OVERALL PLAN

V1_Lighting Plan.pdf Markup Summary

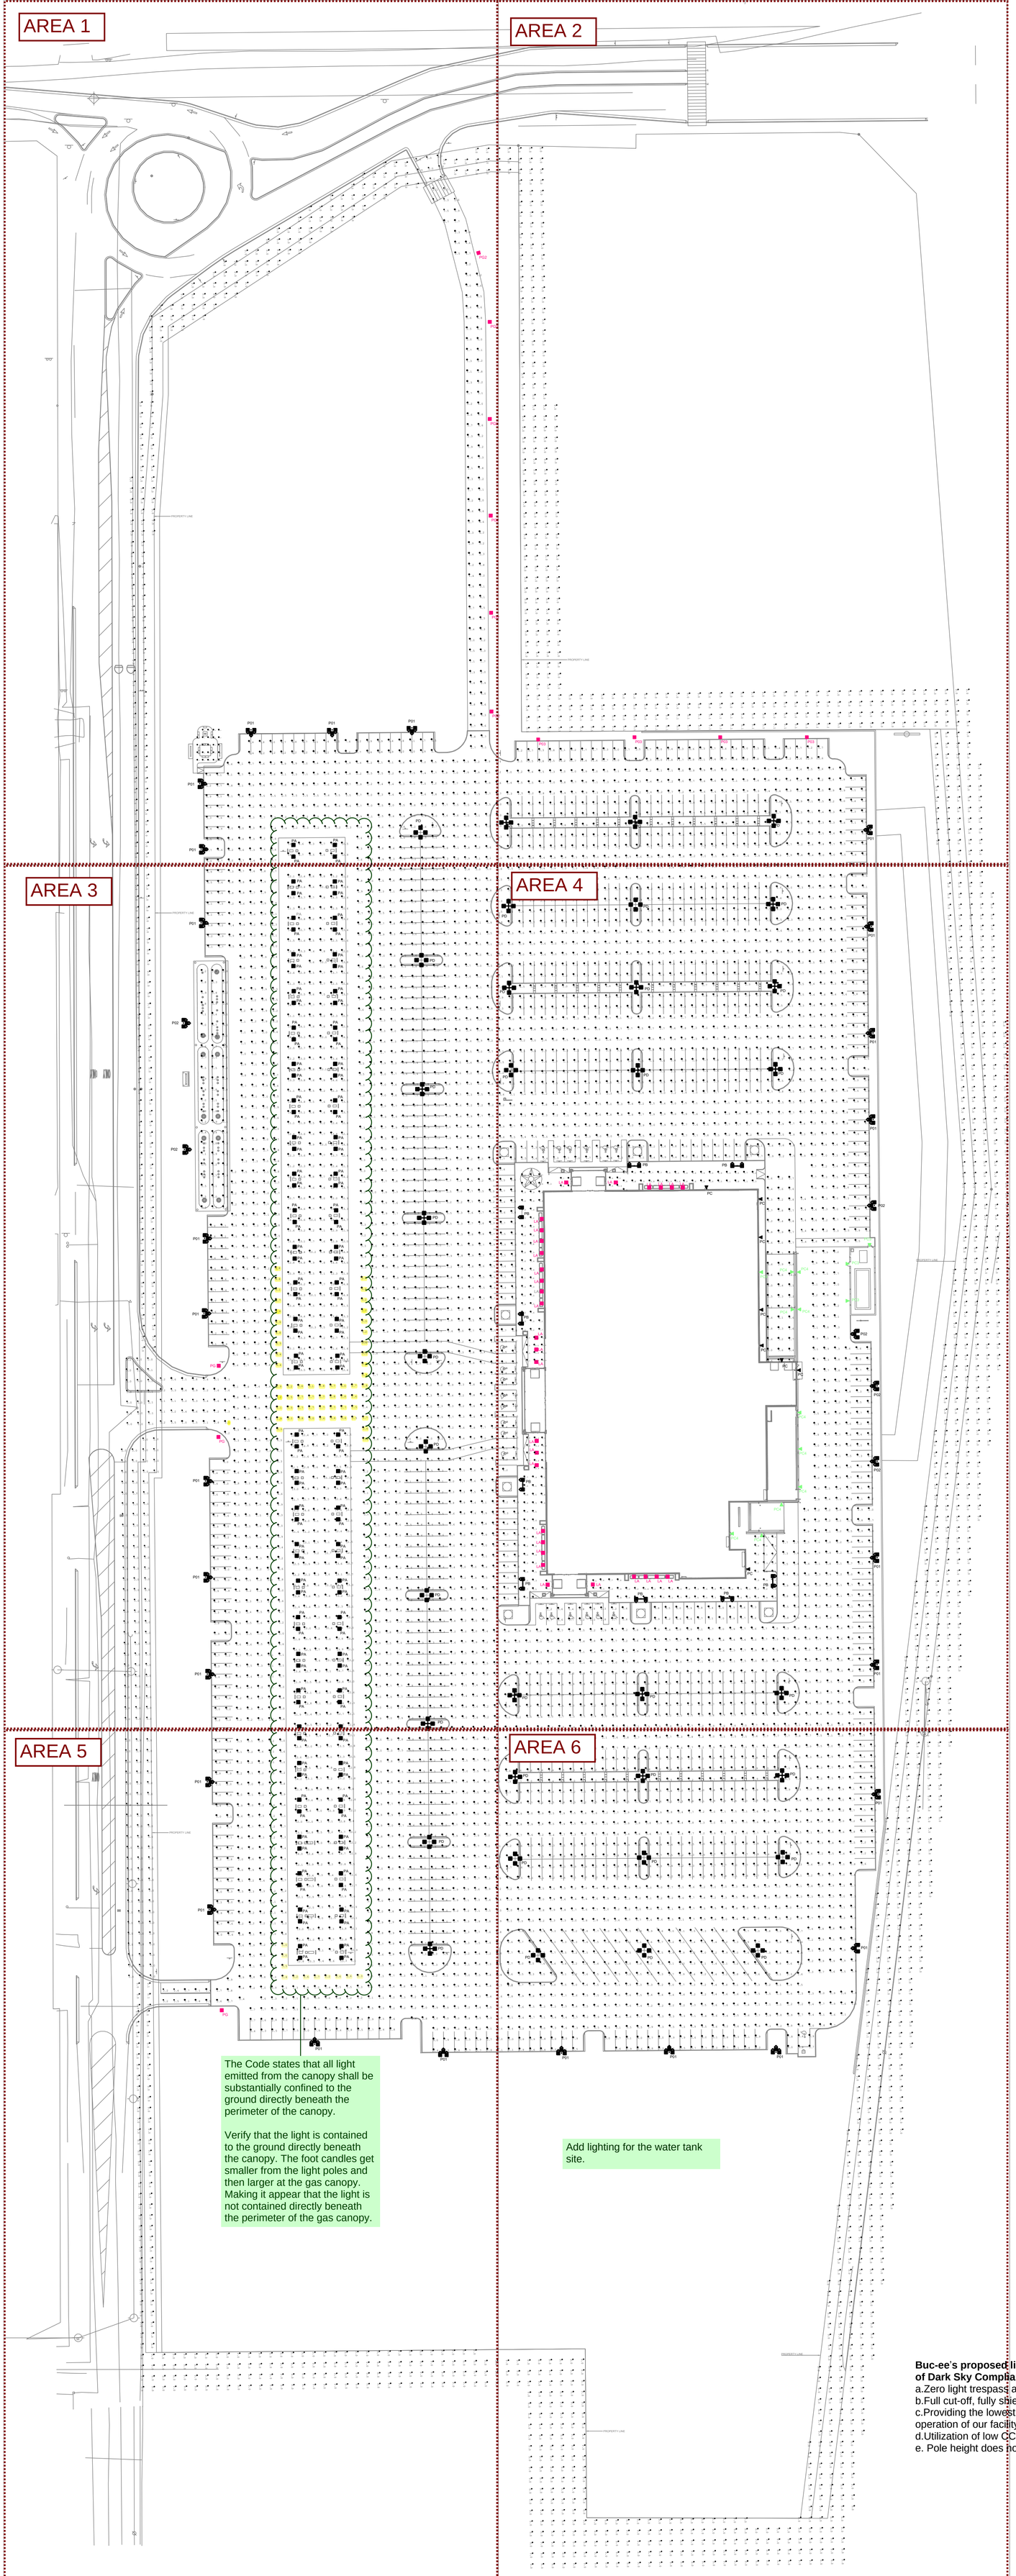
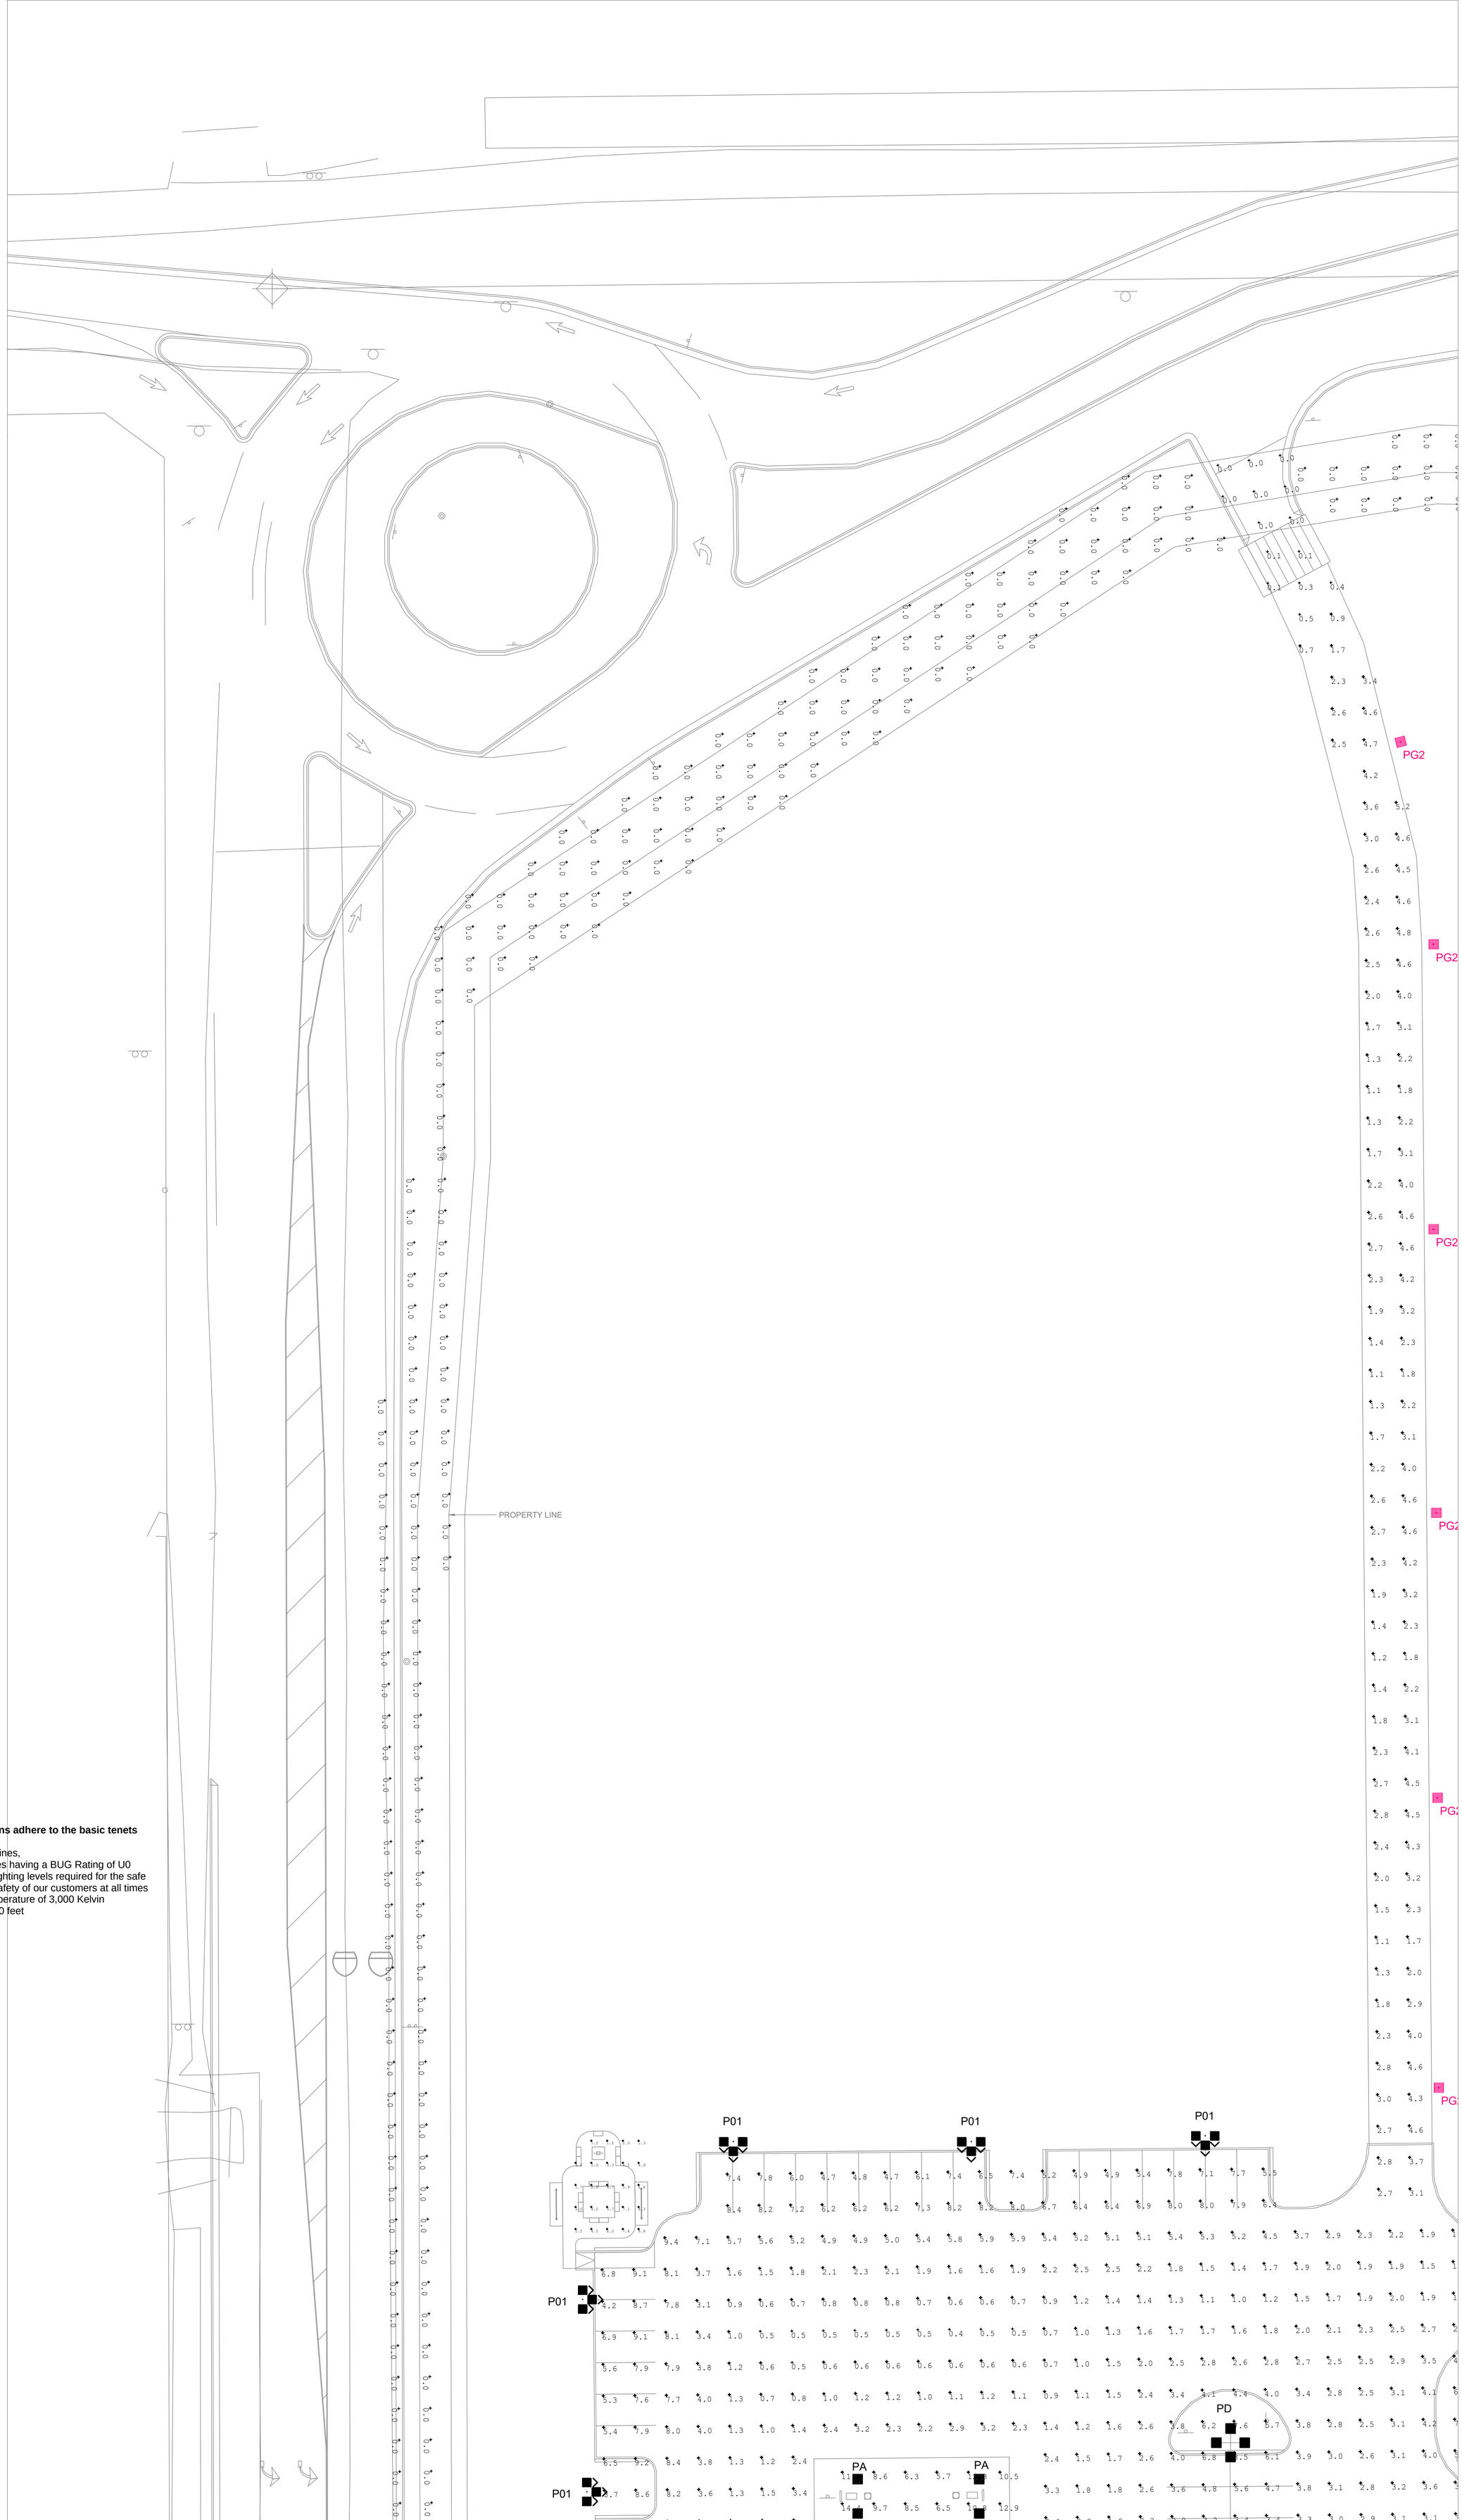
6.2.3. Lighting

(f)Light Standards and Fixtures. The style of light standards and fixtures shall be consistent with the style and character of architecture proposed on the site. Poles shall be anodized or coated to minimize glare from the light source. Bollards or similar light fixtures intended to illuminate landscape features or walkways are permitted which do not exceed 4 feet in height, 2 fixtures per bollard and 1 lamp not exceeding 900 lumens per fixture.

The Code states that all light emitted from the canopy shall be substantially confined to the ground directly beneath the perimeter of the canopy.

Verify that the light is contained to the ground directly beneath the canopy. The foot candles get smaller from the light poles and then larger at the gas canopy. Making it appear that the light is not contained directly beneath the perimeter of the gas canopy.

Add lighting for the water tank site.
